**RESPONSE TO APRIL 9, 2001 AND APRIL 26, 2001
REQUEST FOR ADDITIONAL INFORMATION IN REGARDS TO REQUEST
FOR LICENSE AMENDMENT
INCREASED LICENSED POWER LEVEL
HOPE CREEK GENERATING STATION UNIT NO. 1
FACILITY OPERATING LICENSE NPF-57
DOCKET NO. 50-354**

ATTACHMENT 1
HOPE CREEK GENERATING STATION UNIT NO. 1
FACILITY OPERATING LICENSE NPF-57
DOCKET NO. 50-354
RESPONSE TO REQUEST FOR ADDITIONAL INFORMATION
INCREASED LICENSED POWER LEVEL

Figure 15D.1: APRM Flux and Core Average Heat Flux (FWCF at 102% Power / 105% Flow)

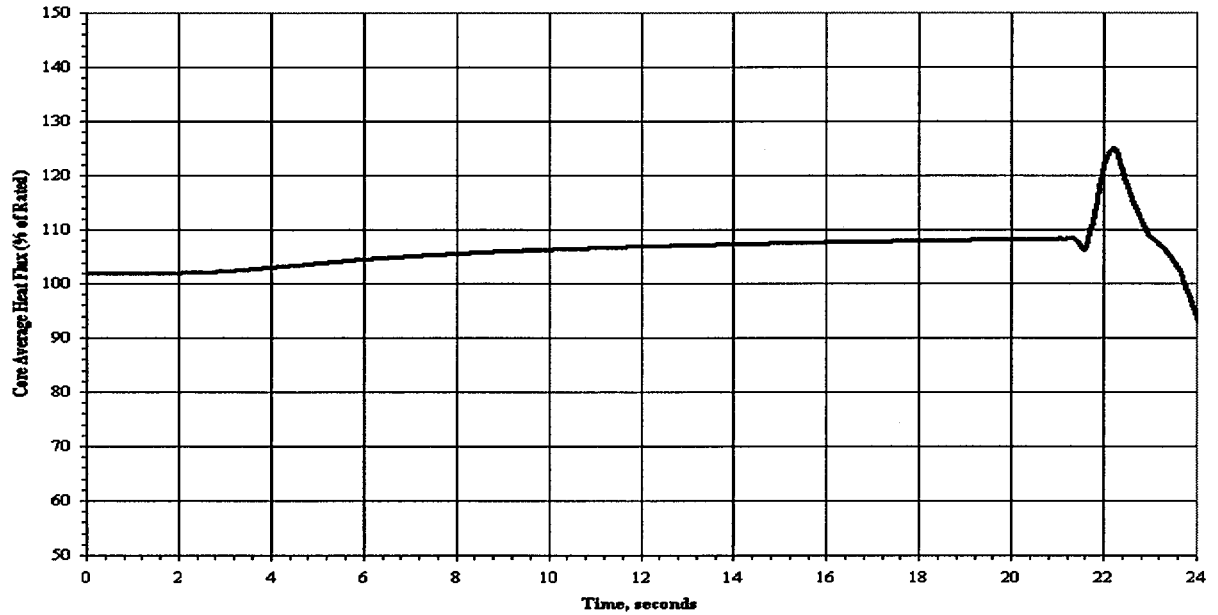
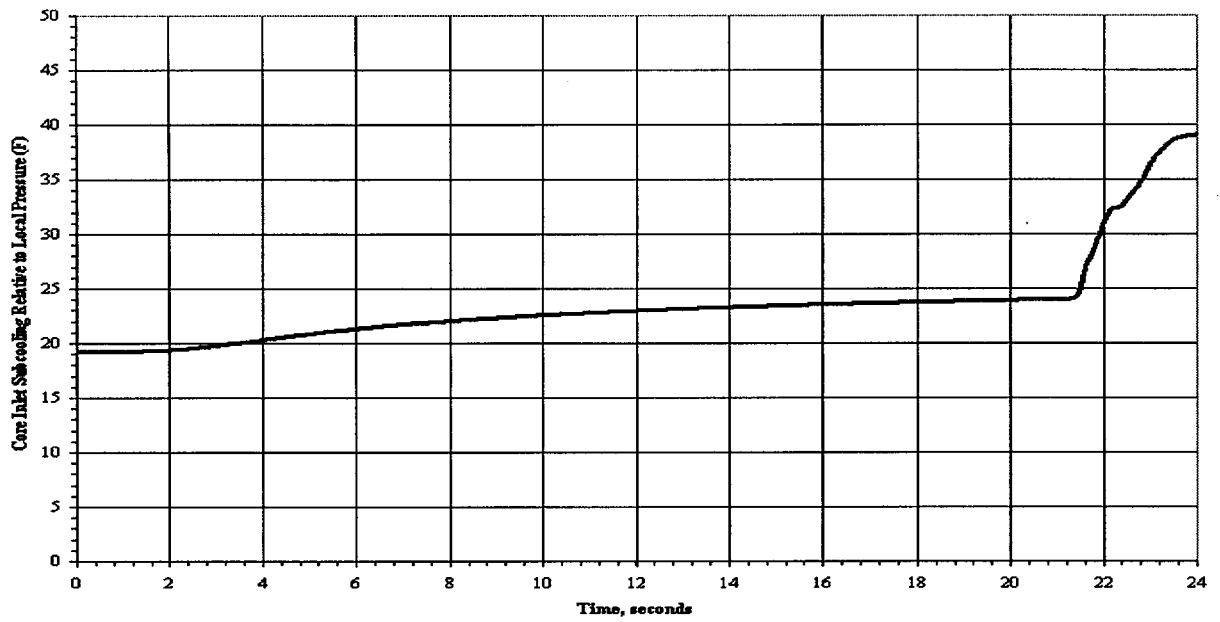
5. In order to assist in the evaluation of the effects of the proposed change on the Updated Final Safety Analysis Report Chapter 15 analyses, please provide a copy of the fuel vendor's supplemental reload analysis report (or similar documentation as discussed in a telephone conversation on March 28, 2001) for the current fuel cycle. This information is required to assure that proposed changes conform to the requirements of:

The following figures copied from the HCGS-UFSAR, Revision 11, November 24, 2000, provide Cycle 10 reload analysis results for selected limiting events.
